UNITED STATES OF AMERICA
NUCLEAR REGULATORY COMMISSION

In the Matter of)
)
SYSTEM ENERGY RESOURCES, INC.) Docket No. 52-009-ESP
)
(Early Site Permit for Grand Gulf ESP Site))

NRC STAFF RESPONSE
TO LICENSING BOARD'S ORDER OF SEPTEMBER 13, 2006

ATTACHMENT A

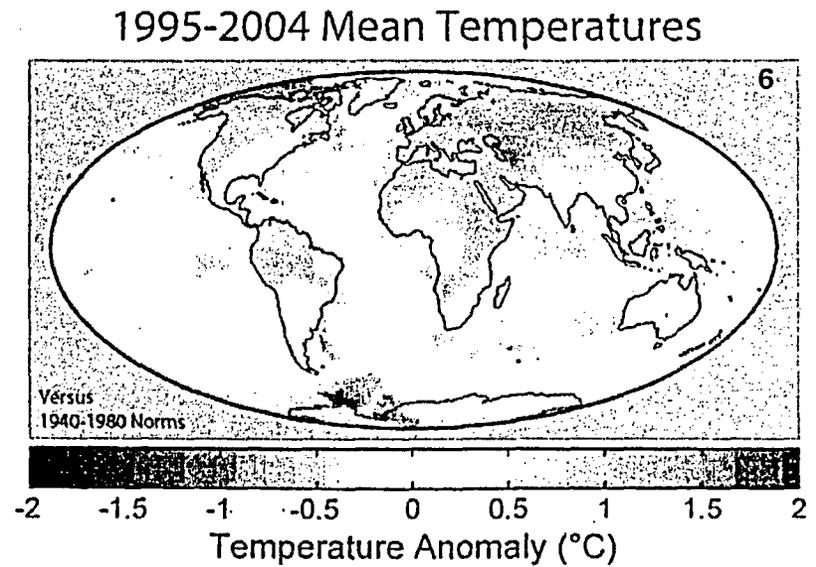
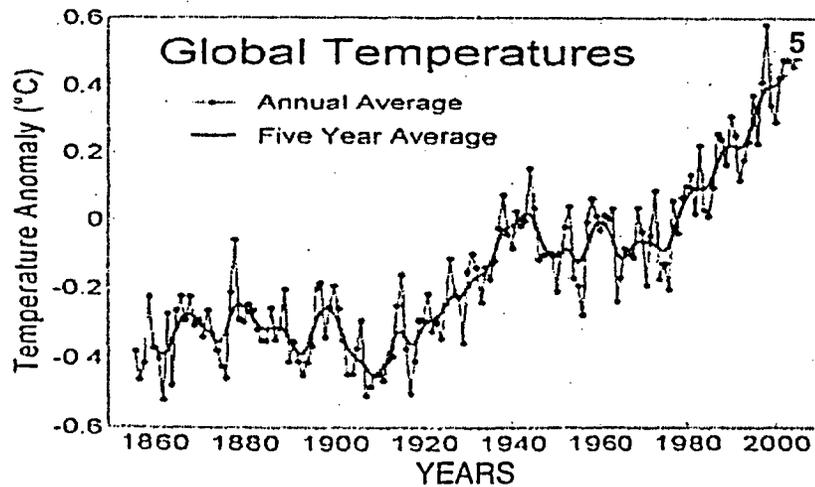
| Inquiry No. | SER Page | SER Section | Inquiry |
|-------------|----------|-------------------|---|
| 17 | General | 2.3.1.3; 2.3.2 | <p>If the Staff were to evaluate all of the meteorological data, hurricane frequencies, etc. (see, e.g., SER pp. 2-33, 2-41), in terms of periodic increments, would it show a trend with the more recent years being more severe? Would this be indicative of climate change effects?</p> <p>Response: See Attachments B and C.</p> |

Figure 1 shows four moving averages of varying time scales, including 5-year, 10-year, 15-year, and 20-year averages of Atlantic basin hurricane frequencies from 1948 through 2005. These data are taken from the National Climatic Data Center (NCDC) (Ref. 1). Since 1995, there is a definite increasing trend in hurricane frequency. On average, there have been around three additional hurricanes each year.

Figure 2 shows both the frequency and intensity of Atlantic basin hurricanes from around 1850 through 2005. There seems to be an observable decadal and multi-decadal fluctuation of hurricane activity. The more recent years, post-1995, show a slight increasing trend in severe hurricanes (e.g., category 4 and 5). From this graph, it is apparent that both hurricane frequency and intensity have increased in the Atlantic basin in recent years.
